Our Ref: Q144007
Our Contact: Mr Dominic Hammersley
Council Ref: 8/13/1481(3693529)

**RESPONSE TO FURTHER ISSUES - RECONFIGURING A LOT
(1 INTO 72 LOTS AND PARK) VIXIES ROAD, WONGA BEACH**

Property Description: Lot 32 on SP126925

Council Reference: 8/13/1481

LAYOUT PLAN - SHEET 3 OF 3
SCALE 1:1000

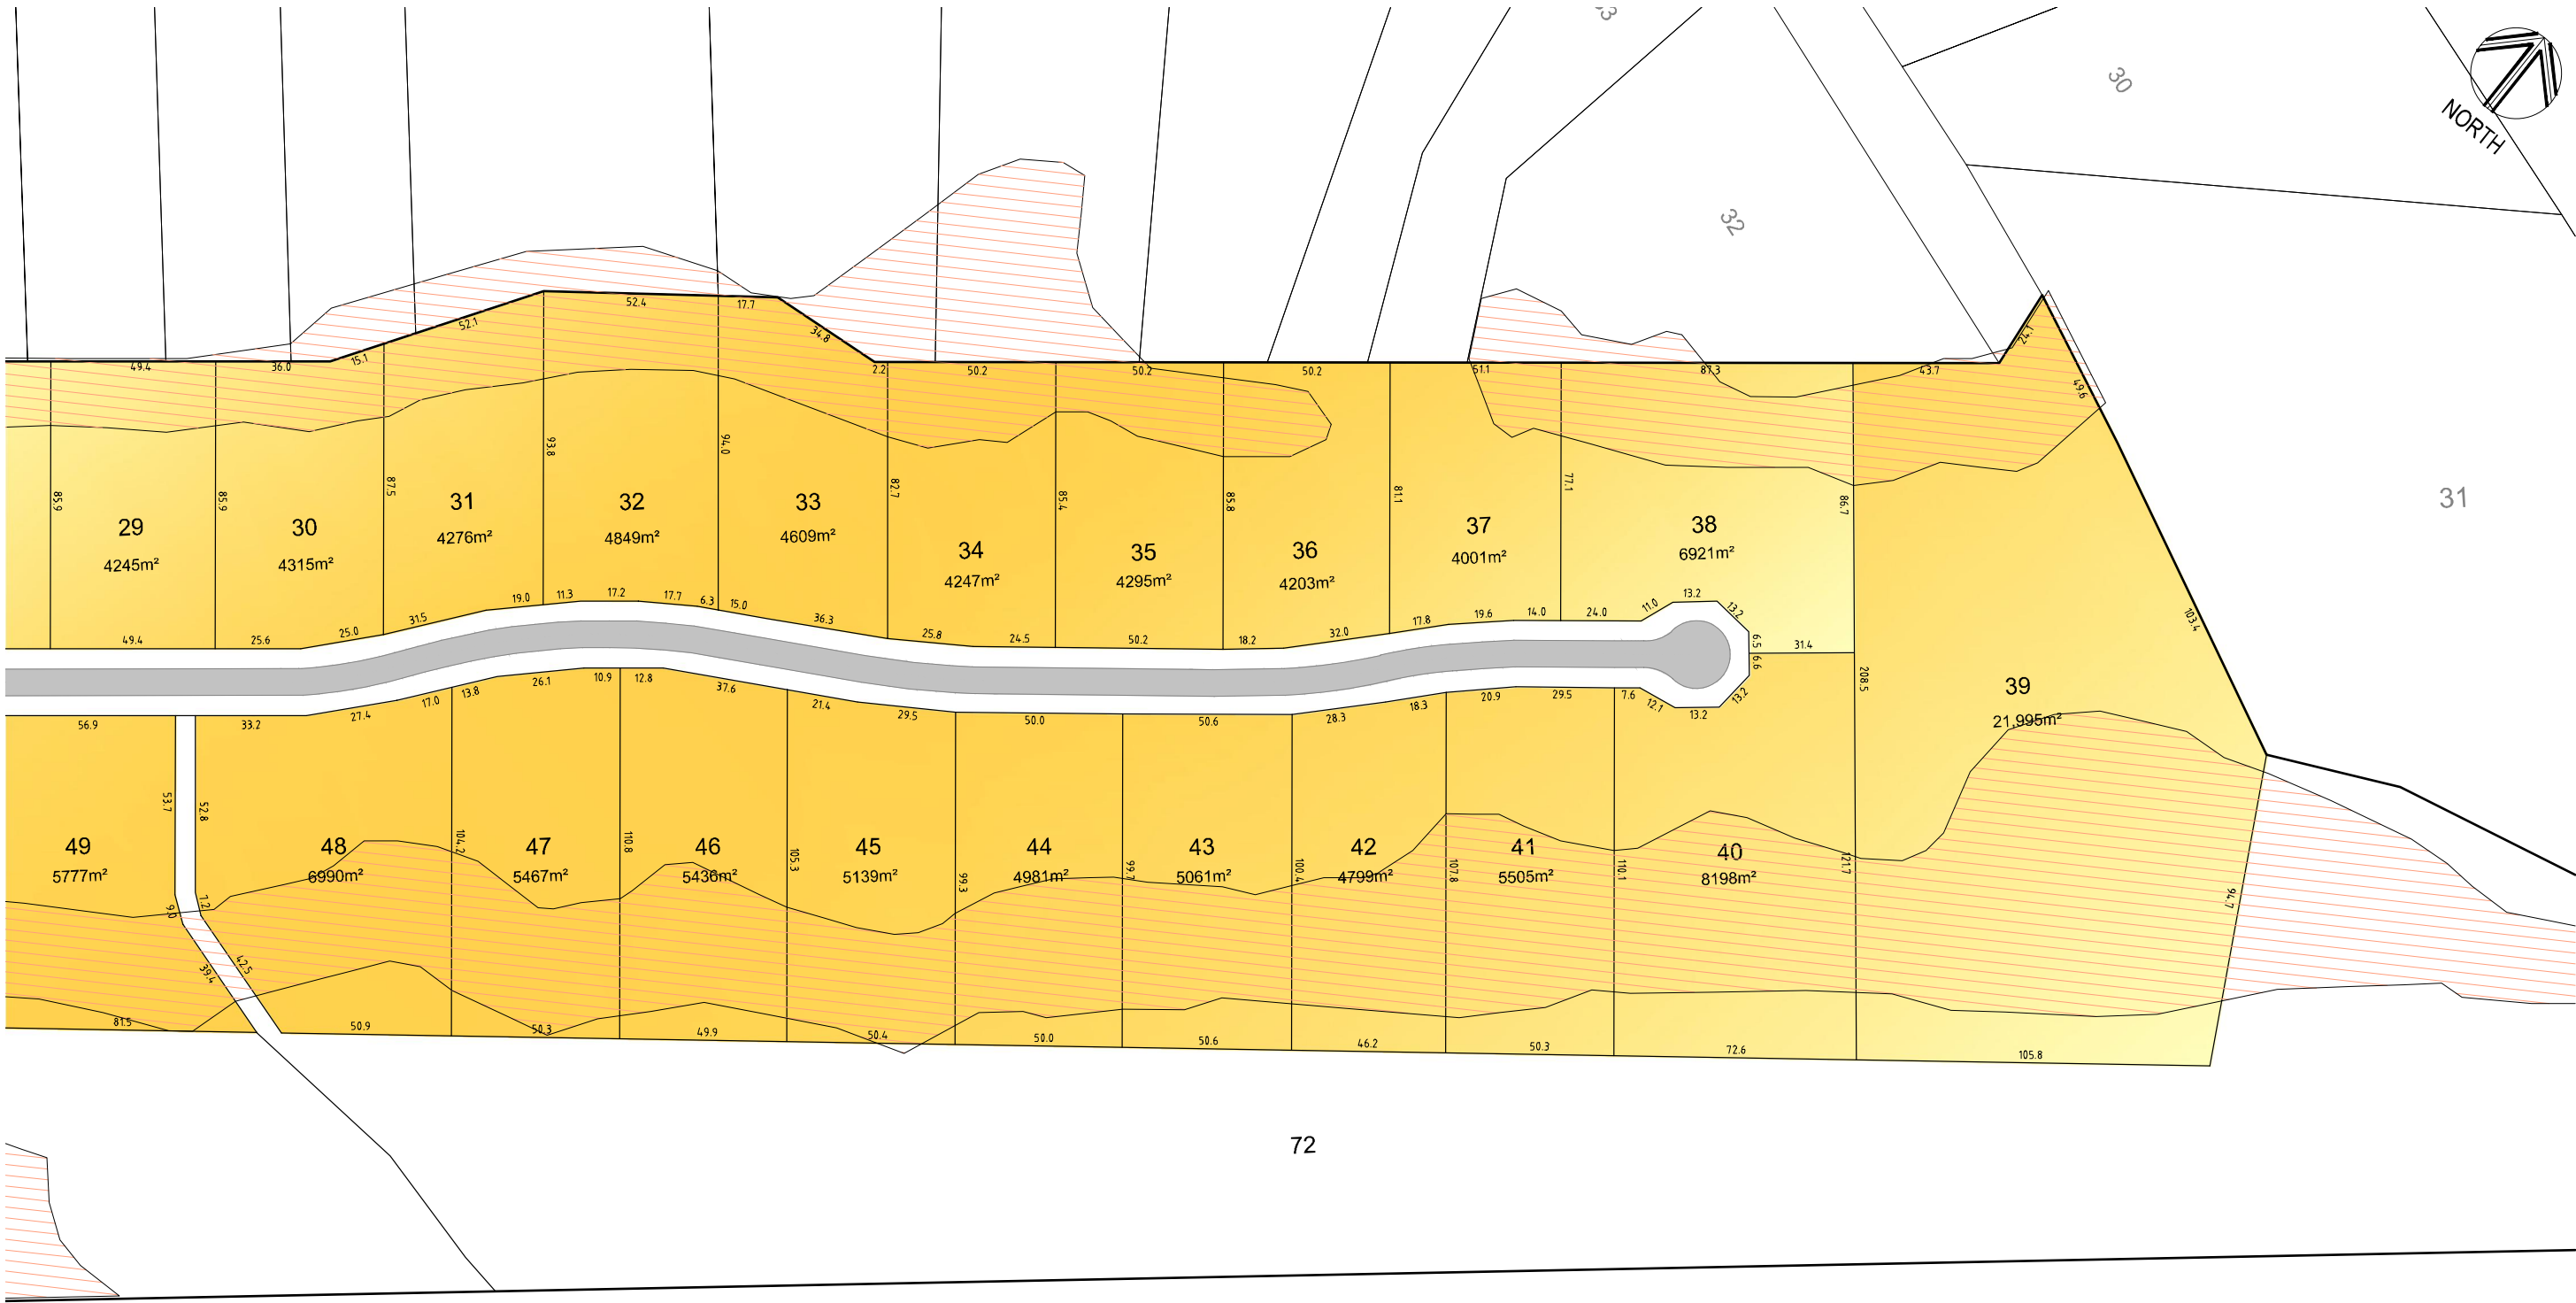
- d., the development concept has been subject to minor refinement in consideration of the current flood extent (refer **Attachment B – Revised Reconfiguring a Lot Plans**); however, the flood inundation risk is not such that the development concept required substantial change.

- > In response to 'Planning' Outstanding Information request item D:
 - o 1., Refer **Attachment A – Revised Reconfiguring a Lot Plans** that includes the dimensions and size of each proposed lot.
 - o 2., We identify a park lot between Lot 57 and 58. The use of this lot was previously unidentified.

- > Re-configuration of the proposed lots to incorporate drainage channels.
- > Refinements to lot boundaries to improve responsiveness to overland flows associated with a 100 year ARI.
- > A shortening of the road leading to the cul-de-sac resulting in the termination of the cul-de-sac at proposed lots 38 and 40.
- > A change of access to proposed lot 39 (now accessed off the road to the north).
- > A change of Applicant details per amended IDAS Form 1.
